**RE: Panda Express – Gibson
2040 Gibson Blvd SE
Grading and Drainage Plan
Engineer's Stamp Date: 06/10/24
Hydrology File: M15D021F**

RE: Panda Express – Gibson
2040 Gibson Blvd SE
Conceptual Grading and Drainage Plan
Engineer's Stamp Date: 09/12/23
Hydrology File: M15D021F

GRADING AND DRAINAGE PLAN

C05.0

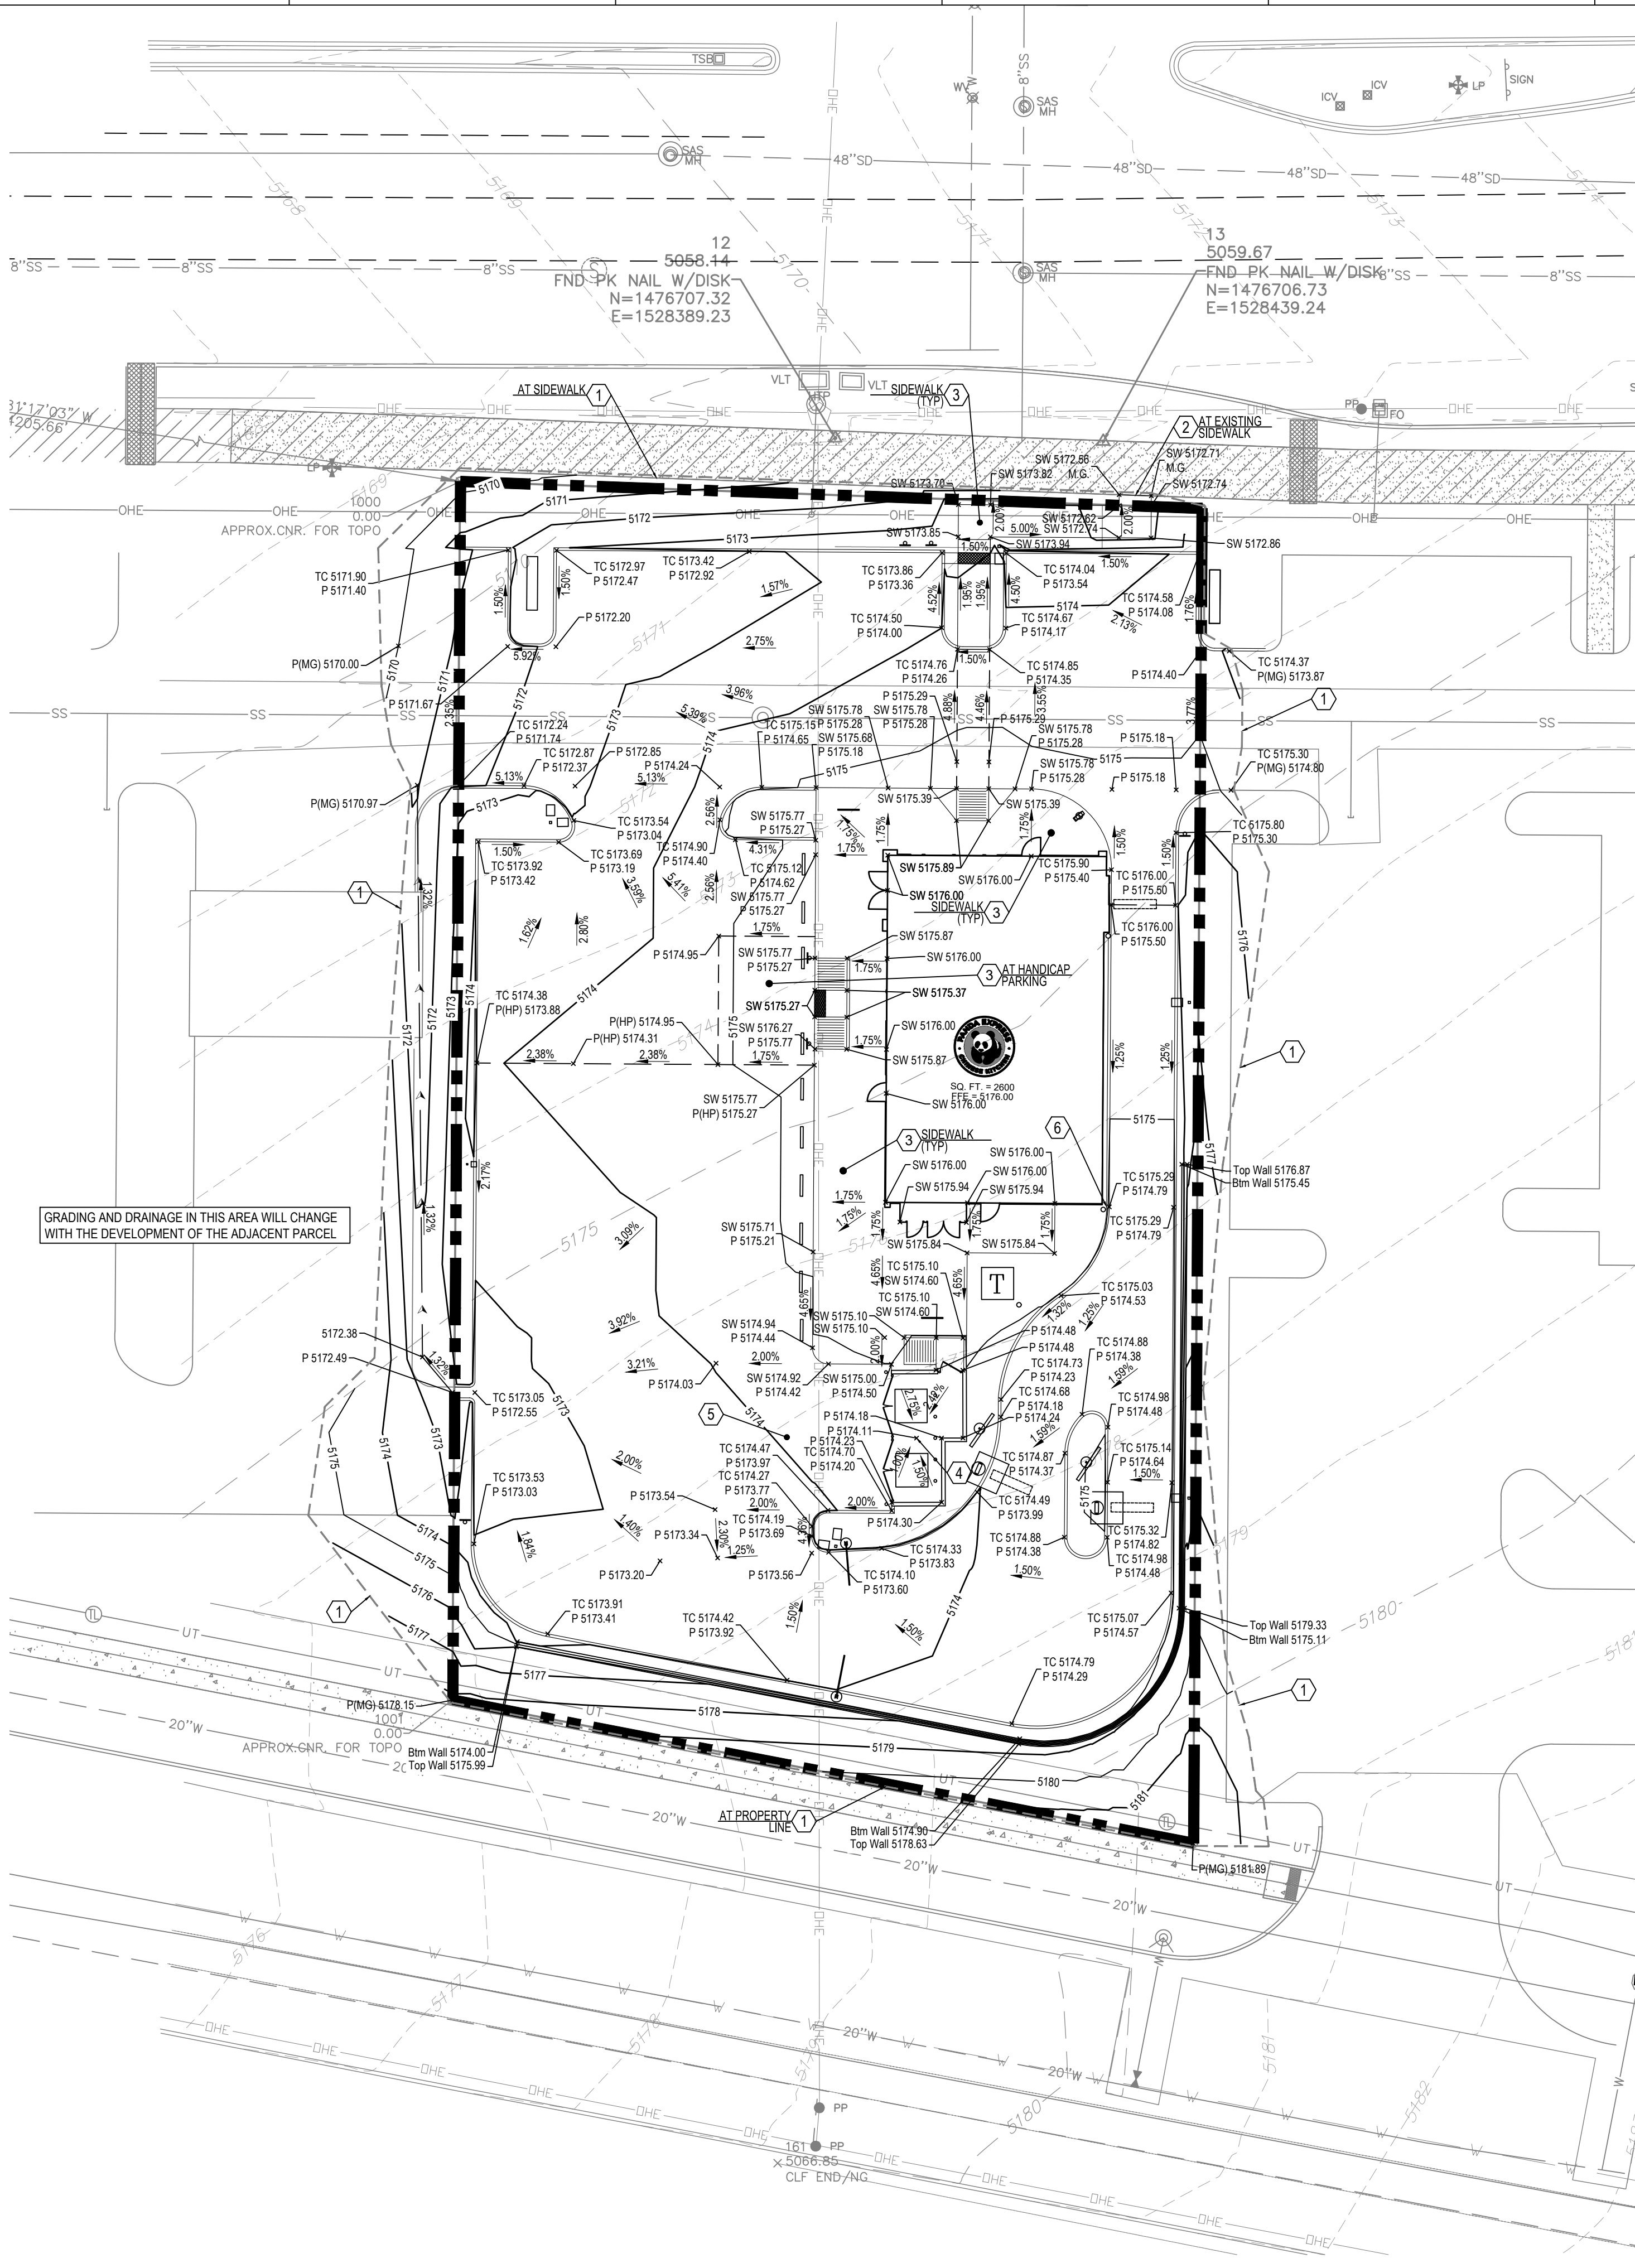
1. Per the DPM, the following must be on the Grading Plan. Please note the Grading Plan must be a stand-alone construction document.

- a. Please provide the Benchmark information (location, description and elevation) for the survey contour information provided.

- b. Please provide a legal Description of the property.

2. Please use the procedure for 40 acre and smaller basins as outlined in Development Process Manual (DPM) Article 6-2(a). Please provide both the existing conditions and proposed conditions for the 100 year-6 hour storm event. This site is part of the Lovelace Heights Drainage Master Plan (attached). Please reference this under the Proposed Conditions. This site has two drainage areas which sheet drains through the adjacent property to a sidewalk culvert.

3. Please follow the DPM Article 6-12 Stormwater Quality and Low-Impact Development for the sizing calculations. To calculate the required SWQV, multiply the impervious area (Square feet) draining to the BMP by 0.42 inches for new development sites divided by

12 to get the required volume in cubic feet. The calculations of both the required and the provided volume of each BMP must be shown on the Grading and Drainage Plan. Each BMP should be labeled on the Grading and Drainage Plan with the required SWQV and associated water surface elevation and the 100-year water surface elevation. Landscaping of surface BMPs is also required to be noted on the Grading and Drainage Plan.

4. Please change the Title of the sheet to "Conceptual Grading and Drainage Plan".

5. Please add the note, "Not for Construction".

6. For trash enclosures serving food service developments, trash enclosures must demonstrate control of liquids from dumpster areas per DPM by containing runoff from the dumpster area, preventing outside drainage from entering the dumpster area, and discharging to the sanitary sewer. Please show an inlet in the middle and label. "Inlet to be connected to the sanitary sewer. See Utility Plan."

Response 1a: Benchmark information provided, see BM 24-L16 on Grading and Drainage Plan C05.0

Response 1b: See Legal Description on Grading and Drainage Plan C05.0

Response 2: See Table of existing and proposed conditions on Grading and Drainage Plan C05.0

Response 3: See stormwater quality on Grading and Drainage Plan C05.0, see also attached waiver.

Response 4: Title is changed to Grading and Drainage Plan C05.0, this cant be conceptual because this approval is for building permit

Response 5: This grading and drainage plan approval is for Building permit

Response 6: Inlet and label added, see keynote 4 on Grading and Drainage Plan C05.0
